**VA24-01; REZ24-01; REZ24-03; & PUD24-03**      **145 S. Morristown Pike** McNeely Law LLP as applicant; William Eric Group, LLC as owner, request a zoning recommendation of “RL” Residential Low Density District, “PUD” Planned Unit Development District, & “PK” Park District Zoning Designations for 169.513 acres +/- collectively upon Greenfield City Council annexation approval. The Property is not yet zoned.

**REZ24-01 RL – Residential Low Density Zoning Proposal**

### **PUD24-02 – Planned Unit Development Zoning Proposal**

**Zoning Conditions, ~~or~~ Waivers, and Commitments**

# SKETCH PLAN

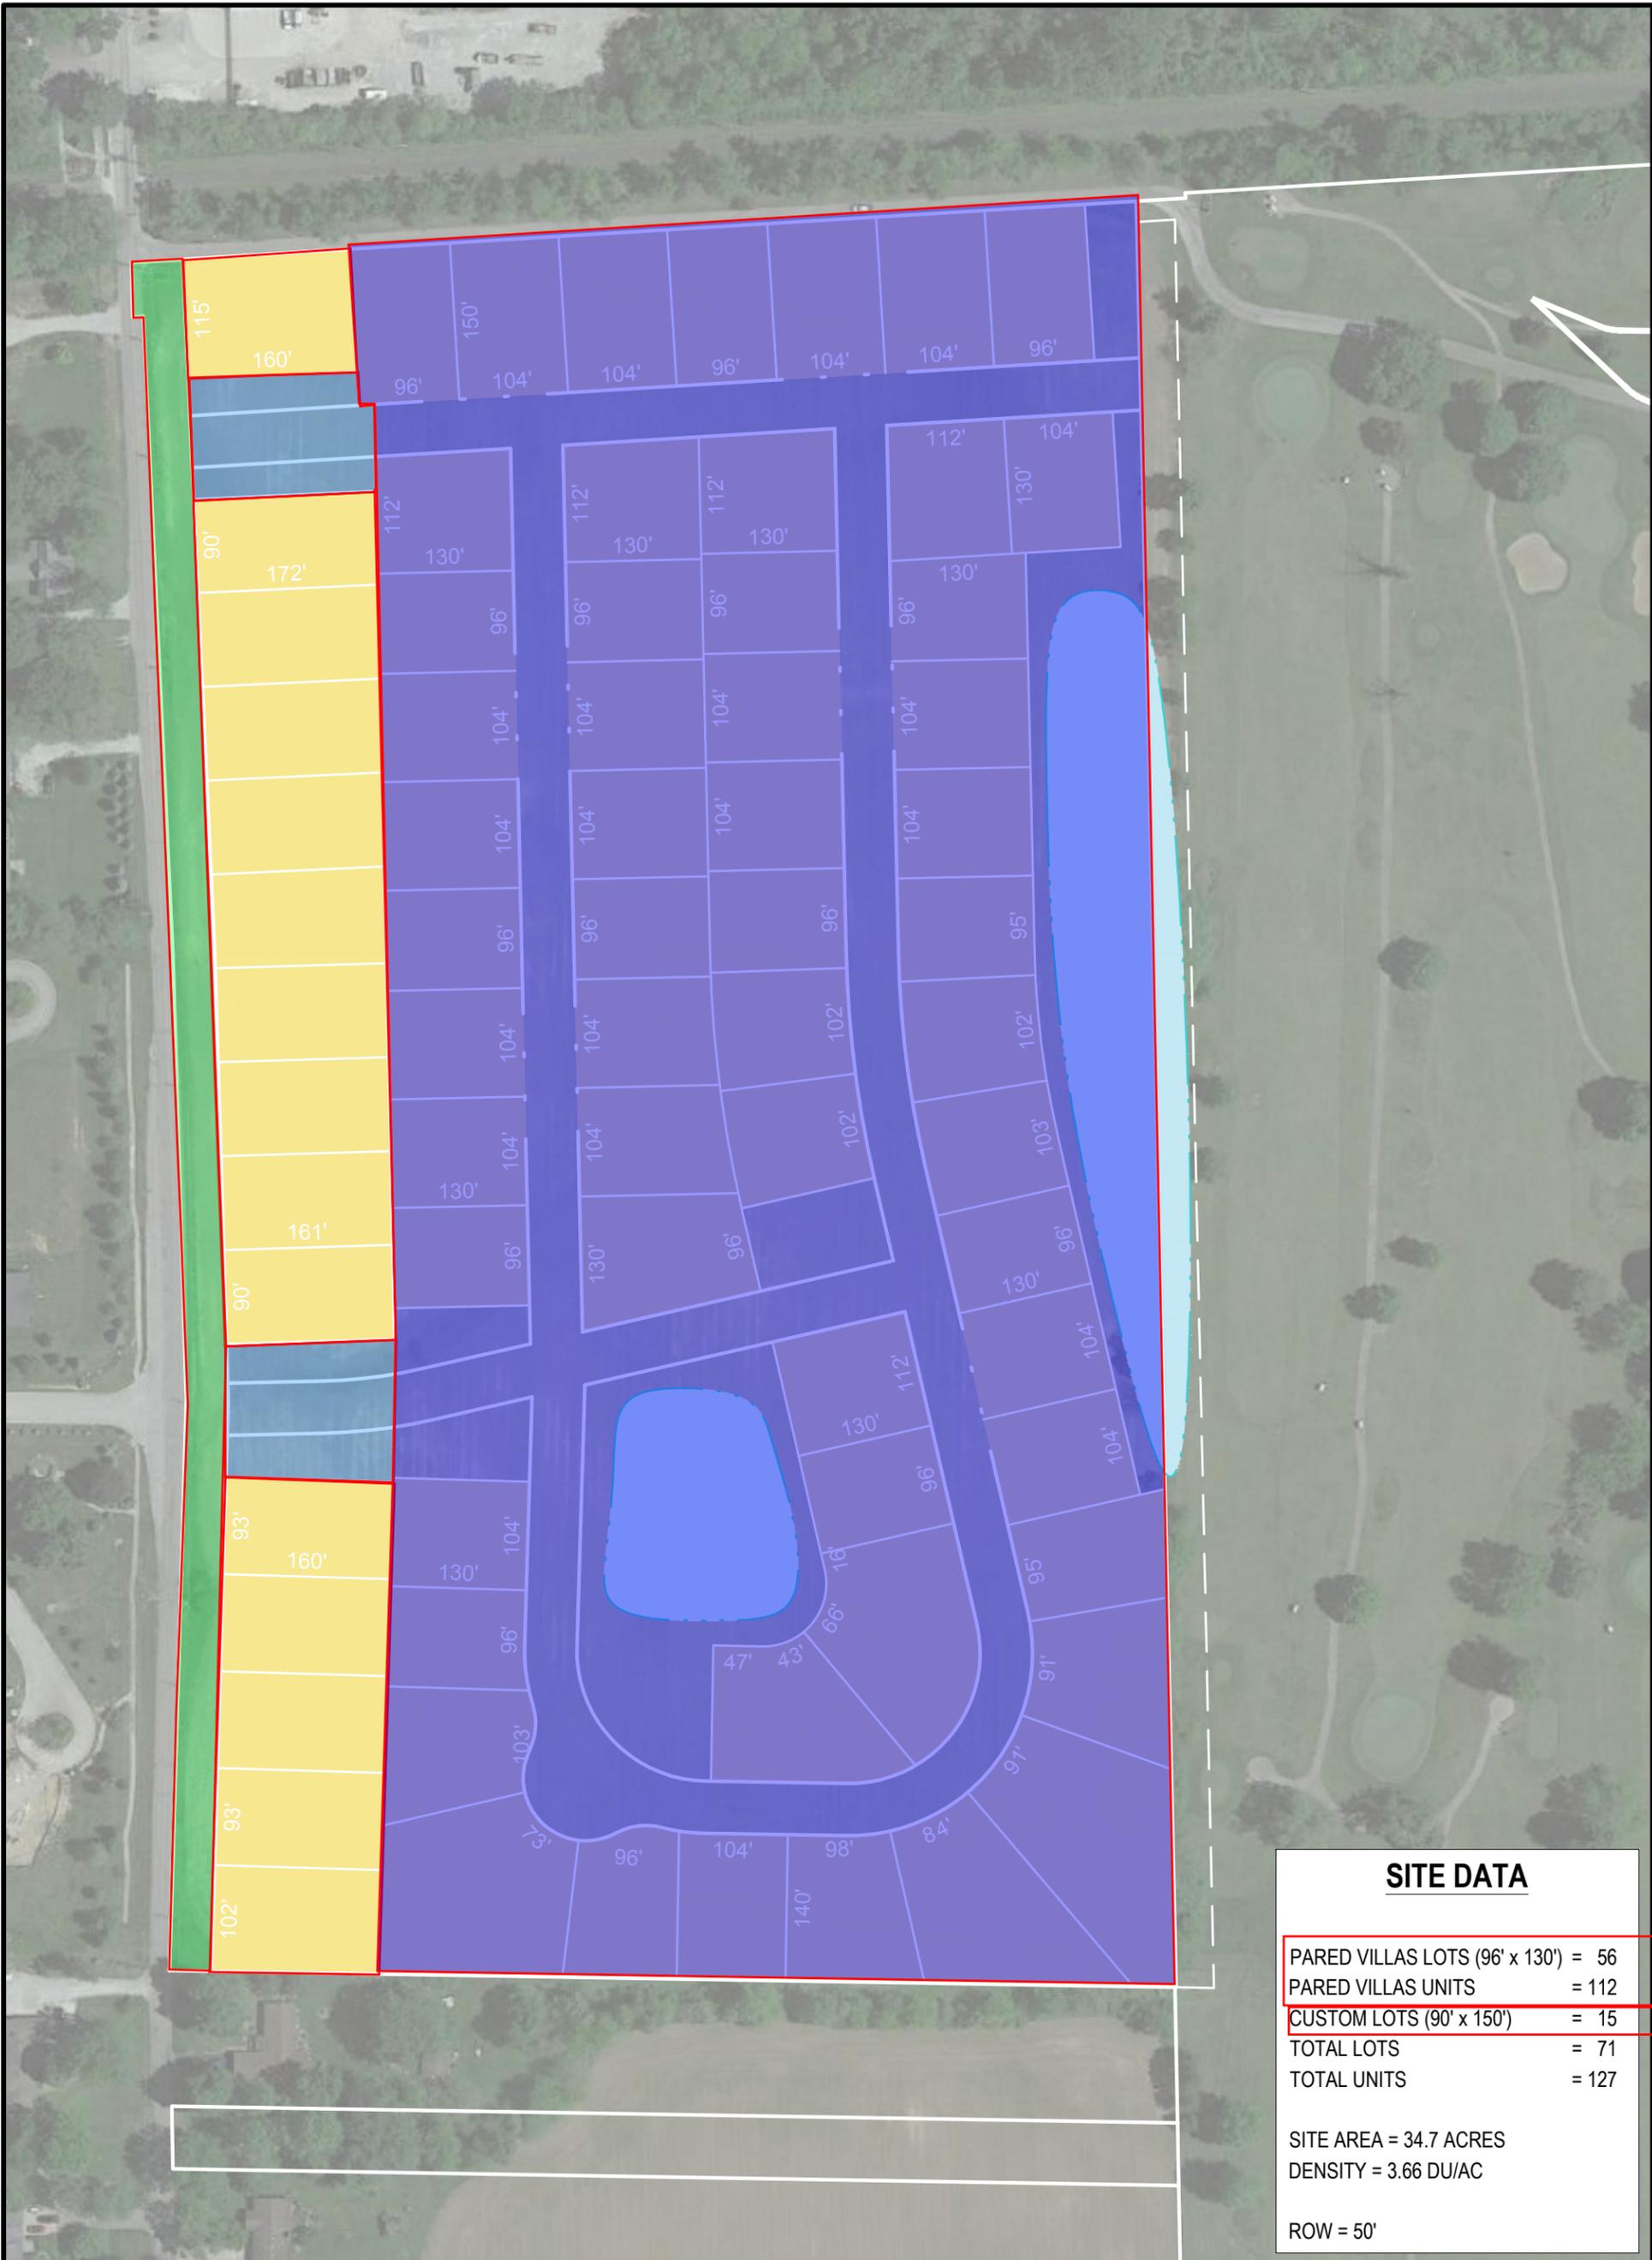
Several plans have been submitted presumably to serve as the adopted Planned Unit Development Plan to be approved and added as an exhibit to the recorded PUD Ordinance. An example of the discrepancies in documents is seen in the Revised Documents provided post-Tech Review by comparing the Overall Zoning Map to the Conceptual Color Rendering to the Sketch Plan documents. The road layout within the PUD districts do not match between the three documents. The number of lots within the PUD districts do not match, either. The Sketch Plan is combing the “Paired Villas” onto a single lot, where-as all other documents and the stated purpose of the proposal is for them to be on individual lots with a shared-wall lot-line. A zoning exhibit of the entire area to be annexed should be created. An accurate Planned Unit Development plan of the PUD property should be created and attached to the PUD Ordinance and PUD Statement.

**Findings:** The PUD does not offer a common area buffer along 10 of the proposed RL lots. The plan shows the rear of these two family units backing up directly to the RL lots. The PUD offers a walking trail on the east perimeter which will provide views of the golf course. Staff has some concerns about fairways and walking trails in the same vicinity although many golf course communities do enjoy lots that abut the course directly. Common areas within the PUD consist of ponds and a dog park. There is not a lot of creativity offered for community gathering spaces such as a clubhouse, or recreational opportunities, such as a playground, a pool, or fitness stations.

- Acreage and densities listed in the Development Statement, the applications, and the sketch plan provided as a PUD plan do not match. Staff needs verification of which document (if any) is accurate, and all documents in error need to be corrected.

The exhibits attached to the PUD Statement show a site layout with 5’ Side Yard Setbacks and 10’ Rear Yard Setbacks. The same PUD document states that the minimum Side Yard Setback is 6’ (for a 12’ aggregate) and that the Rear Yard Setback is 15’ + Easements. This type of inconsistency is common throughout the proposal and is a large part of why Staff considers the documents for this Petition to be incomplete and insufficient.
